# Illustrated Parts List - IPL Update

T525

1. Added a new CLUTCH DRUM ASSY (0.325 mini 7T)
2. Replacement instruction for HOUSING ASSY and COVER

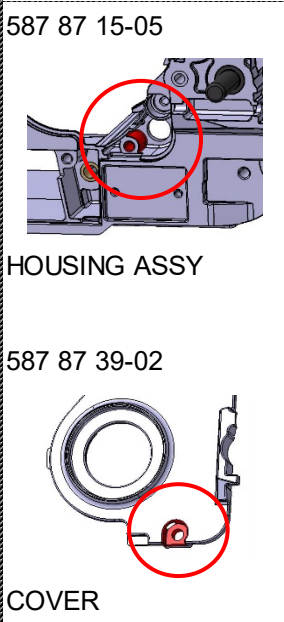
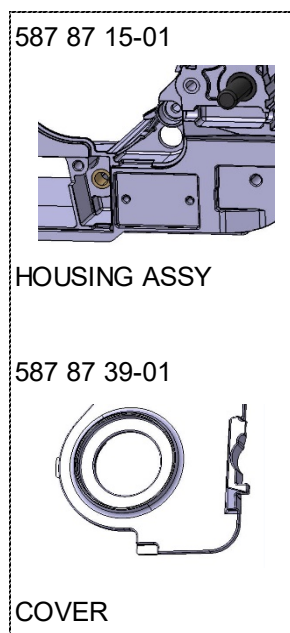
2. 587 87 15-01 fits only with 587 87 39-01 (see pictures below).  
When the stock of 587 87 15-01 and 587 87 39-01 is used up for s/n before 20182699999, use set 587 87 15-05 and 587 87 39-02 for all s/n.

Serial number / Date	Remark
Up to s/n 20182699999	Use set 587 87 15-01 and 587 87 39-01 until stock is used up
From s/n 20182700001	Use set 587 87 15-05 and 587 87 39-02
